CITY OF DULUTH

File Number	PL 18-122	Contact	Jenn Reed Moses
Type	MU-W Planning Review	Planning Commission Date	November 13, 2018
Deadline for Action	Application Date	September 20, 2018	60 Days November 19, 2018
	Date Extension Letter Mailed	October 1, 2018	120 Days January 18, 2019
Location of Subject	1033 Minnesota Avenue		
Applicant	Park Point Marina Inn and Suites LLC	Contact	Terry Anderson
Agent	N/A	Contact	N/A
Legal Description	010-4390-02090, 010-4400-00780		
Site Visit Date	October 2, 2018	Sign Notice Date	September 25, 2018
Neighbor Letter Date	October 1, 2018	Number of Letters Sent	23

Proposal

The applicant is proposing a 3 story, 6,100 square foot, 15 room addition to the southeast side of the existing hotel. Staff has revised the report and proposed conditions since the October 9, 2018 Planning Commission meeting where the Applicant's request was tabled.

1 SITE CONCEPT PLAN
 1" = 20'-0"

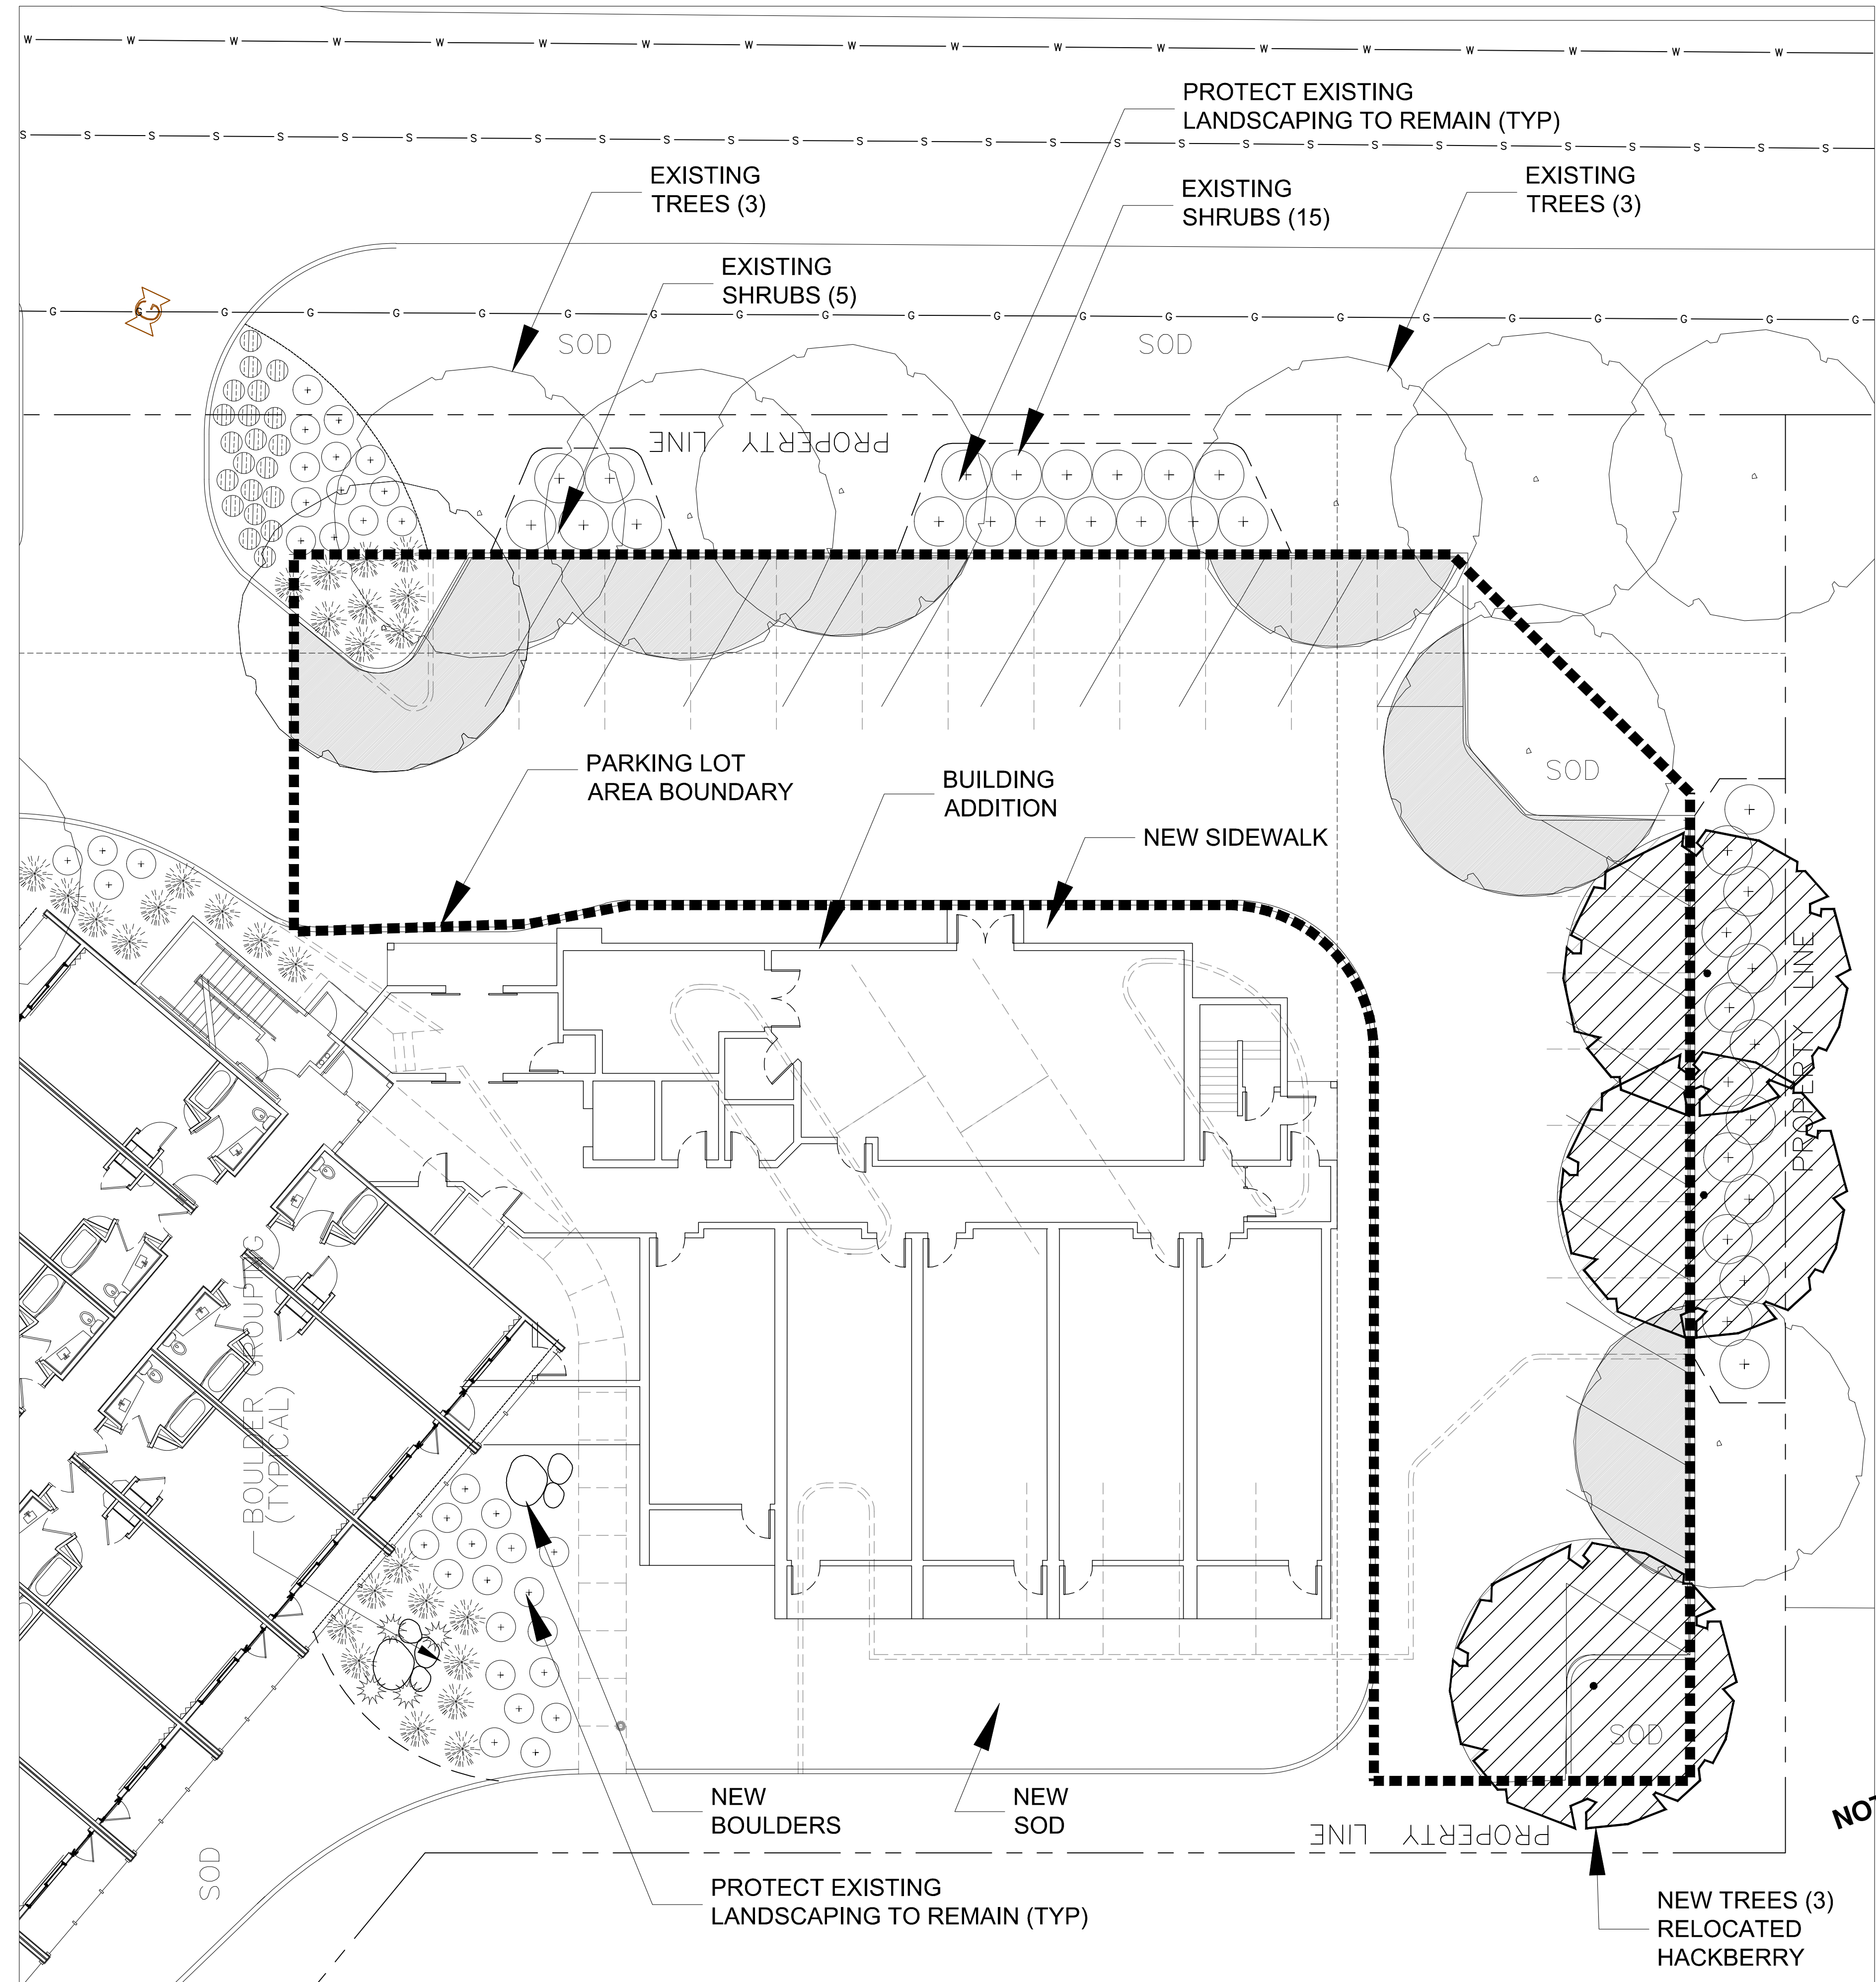
- 4) 50-18.1 (Natural Resources Overlay District) - Site is within a floodplain and will need to meet elevation requirements. Structure meets the 50 foot shoreland setback requirements. The proposed plan eliminates

some stormwater control features (landscape island SE corner of the site). According to City Engineering, this infiltration basin will need to be replaced somewhere else on the site, with plans for its replacement completed prior to issuance of a building permit.

- 6) 50-24 (Parking) - Off-street parking requirements for hotels are based on the number of rooms and accessory areas. 87 parking spaces are required. The applicant is proposing 74 off-street parking spaces. The 30% reduction is not applicable here because of the site's location related to adjacent R-1 properties. This site was previously developed with the 30% reduction for transit proximity; however, the proposed 15-room addition is located on previously required parking areas. The addition of hotel rooms will increase parking demand. Additional staff evaluation of transit use by hotel customers or employees indicates that such use is negligible based on the lack of regular, reliable transit service in this location. The application fails to demonstrate that nearby properties provide supplemental on-street or off-street parking. The site plan indicates that the hotel will rely on the adjacent marina's drive aisle for parking access, and that an easement for this use has been recorded.

4. Prior to issuance of a building permit, Applicant shall provide an additional 13 parking spaces on or immediately adjacent to the site, or demonstrate that supplemental parking is available within 500 feet of the site with off-street pedestrian access using a trail or sidewalk connecting to the hotel's primary entrance.

PROPOSED ADDITION - HARBOR ELEVATION

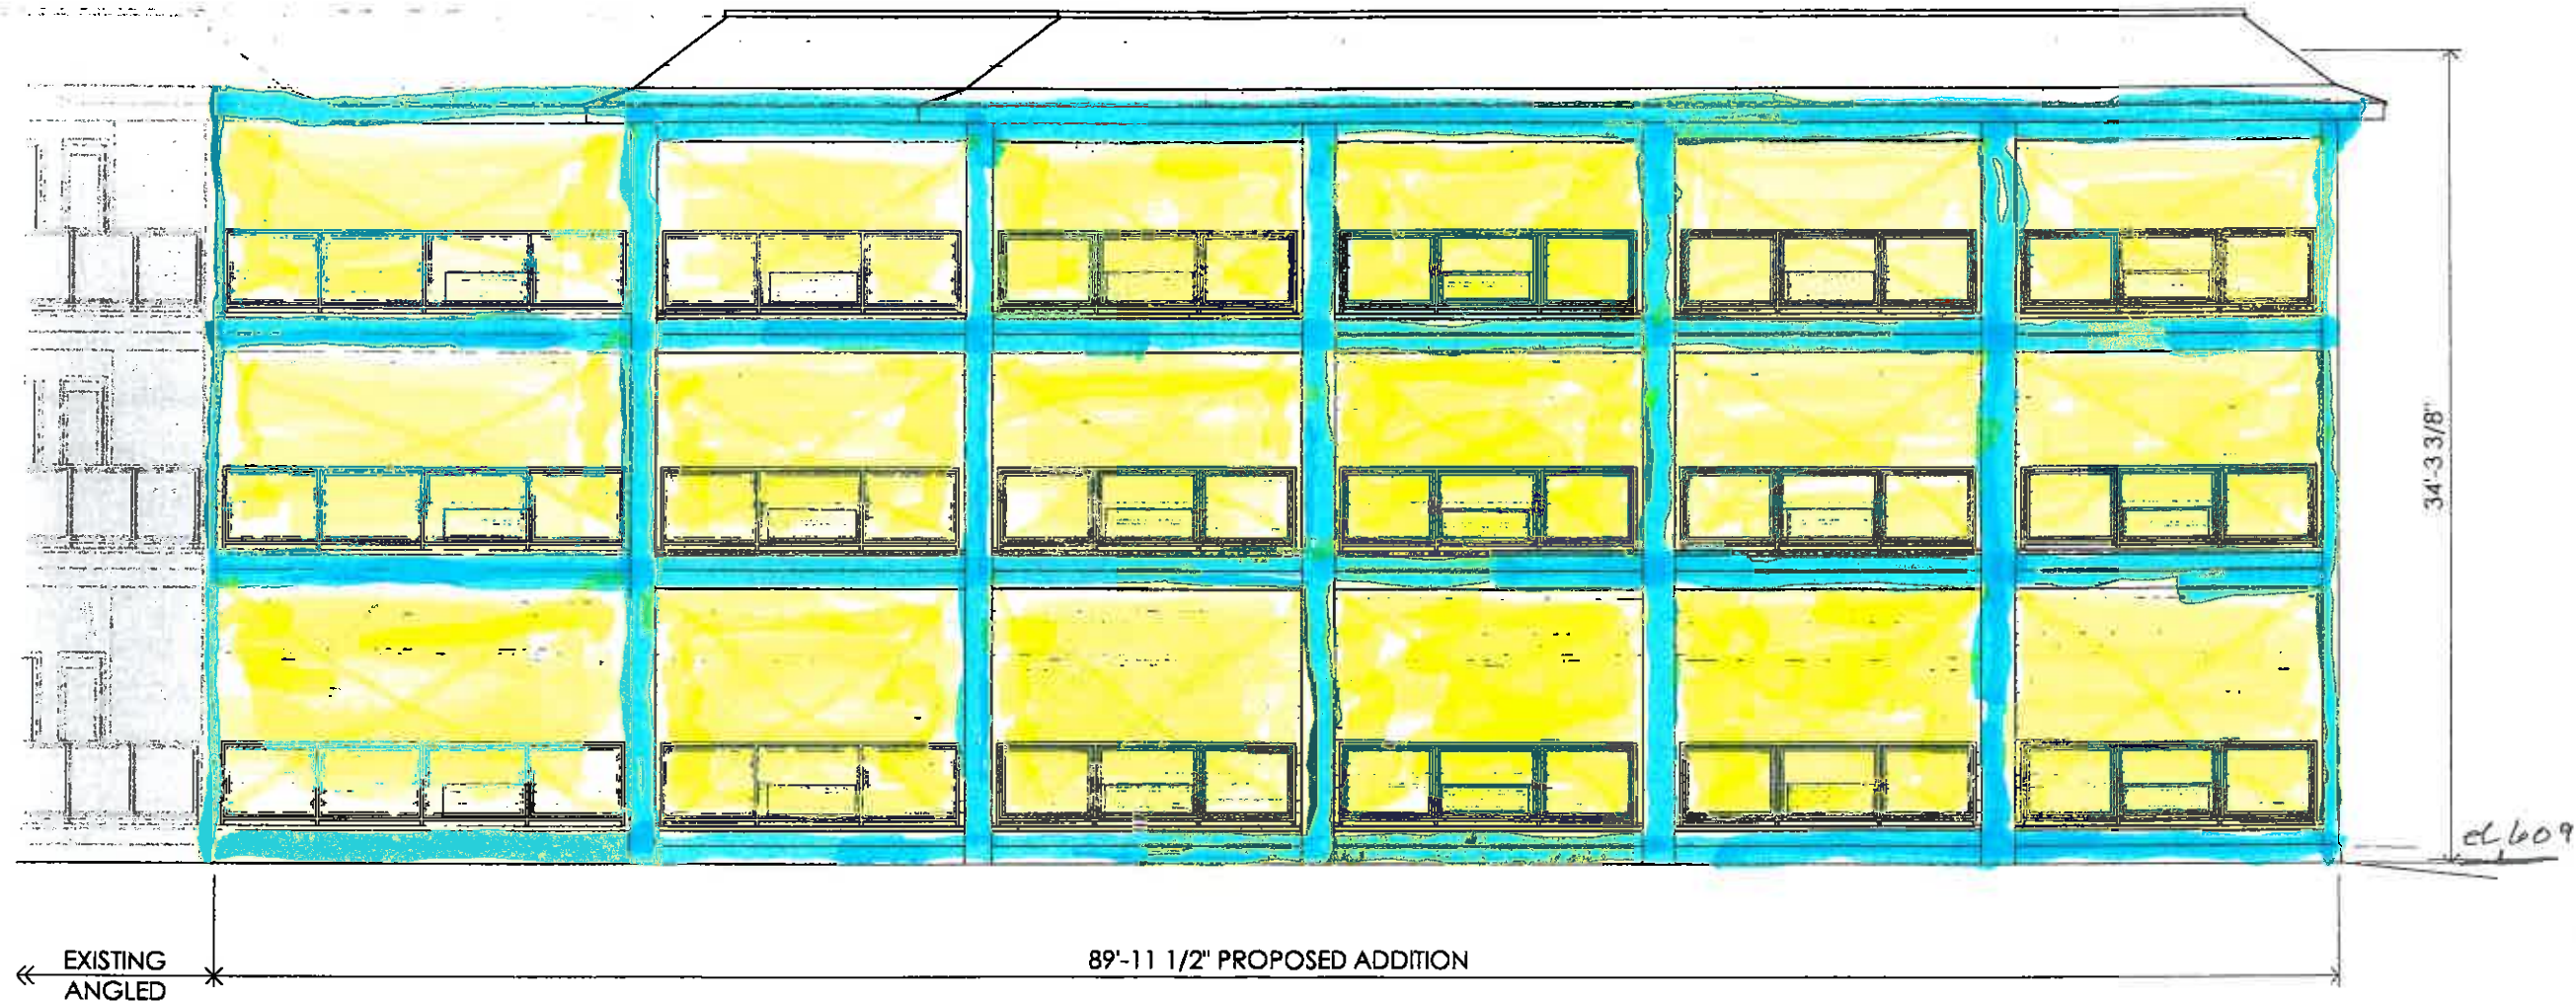
- 3) 50-15.6.E (Development Standards) – #2 The proposed expansion will meet the required minimum 50 foot setback from adjacent structures. #4 Applicant states the project will meet the minimum 40% transparency requirement along the waterfront. #5 The proposed expansion will add rooms and take away existing off-street parking spaces; see item 5 below.

3. Prior to issuance of a building permit, Applicant shall submit professionally drawn elevations signed by a Licensed Architect that include measurements demonstrating that the façade facing the water meets the 40% transparency requirement of the UDC.

Building façade will be designed to meet 50-15.6 E.4
